Access Compliance Report

Public Rights-of-Way

(Curb Ramps)

Intersection ID: 7201	Main Street: PICKERING_DR	Cross Street: W_ROCKY_RIVER_RD	Location: E
ADA ID: 7763D28B782E	Ramp Type: Perp	Initial Pass/Fail: Fail	Overall Compliance: No
			Severity Score: 26.25

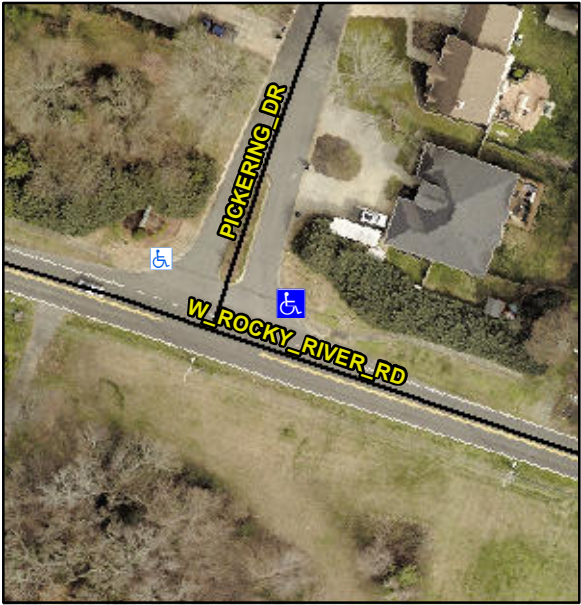
Codes/Mitigation Info/Possible Solution			Field Measurements/Component Compliance		
	Possible Solutions:		Compliance	Description	Data
	Remove & Replace Entire Ramp.		N/A	Ramp Length (in)	48.0
			Yes	Ramp Width (in)	48.0
			N/A	Flare Type LT	N/A
			N/A	Flare Slope LT (%)	N/A
			N/A	Flare Traversable LT?	N/A
			N/A	Landing Length (in)	N/A
			N/A	Landing Width (in)	N/A
			N/A	Landing Slope (%)	N/A
			N/A	Landing X Slope (%)	N/A
<p>Surveyor Notes:</p> <p>N/A</p> <p>PROW/ADA:</p> <p>Not Found, R304.2.2, R304.5.3</p>			N/A	Flare Type RT	N/A
			N/A	Flare Slope RT (%)	N/A
			N/A	Flare Traversable RT?	N/A
			N/A	DWS Provided?	N/A
			N/A	DWS Contrast?	N/A
			N/A	DWS Length (in)	N/A
			N/A	DWS Full Width?	N/A
			N/A	DWS Offset (in)	N/A
			N/A	Shared Landing?	N/A
			N/A	Gutter Ponding?	N/A
			N/A	Gutter Lip Ht (in)	N/A
			N/A	Painted X Walk1?	No
				X Walk 1 Direction	To NW
			N/A	X Walk 1 Width (in)	N/A
				X Walk 1 Slope (%)	2.4

X Walk 1 X Slope (%)	2.1
			N/A	Ramp inside XWalk1?	N/A
				Road Slope (%)	N/A
				Road X Slope (%)	N/A
			N/A	Any Obstructions?	N/A
				Obstruction Type	
Total Cost:		\$ 1850.00			
			N/A		N/A
			Yes	Surface Condition? (G/P)	Good
